SAFETY RECALL CODE 0807 - 1997/1998 FRONT BRAKE ROTOR DRIVE PINS

B-013

Figure 1. Drive Pin Assembly

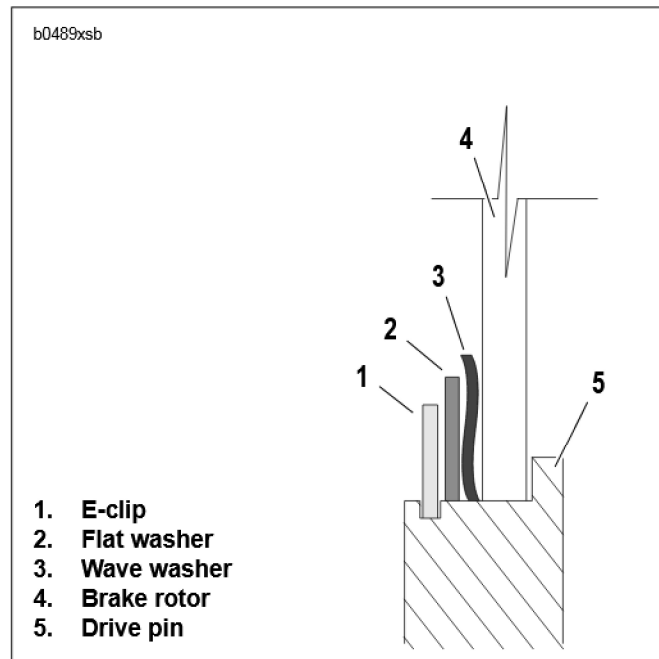
Buell has determined that the drive pin(s) used on the front brake rotor could move out of position and come in contact with the front brake caliper. This condition could prevent the front wheel from rotating. This could occur without prior warning.

2. See [Figure 1](#). Remove existing drive pin assemblies two at a time.
 - a. Gently pry E-clip (1) away from drive pin (5).
 - b. Completely remove E-clip using a thin bladed screwdriver. Discard E-clip.
 - c. Remove and discard flat washer (2), wave washer (3) and drive pin (5).
3. See [Figure 2](#). Install **new** drive pin hardware through rotor (5) and carrier (8).
 - a. Place drive pin (6) between rotor and carrier. Shoulder on drive pin faces away from wheel hub.
 - b. Insert bolt (7) through drive pin (6).
 - c. Install wave washer (4) on back side of rotor.
 - d. Install flat washer (3).
 - e. Install drive pin flat washer (2).
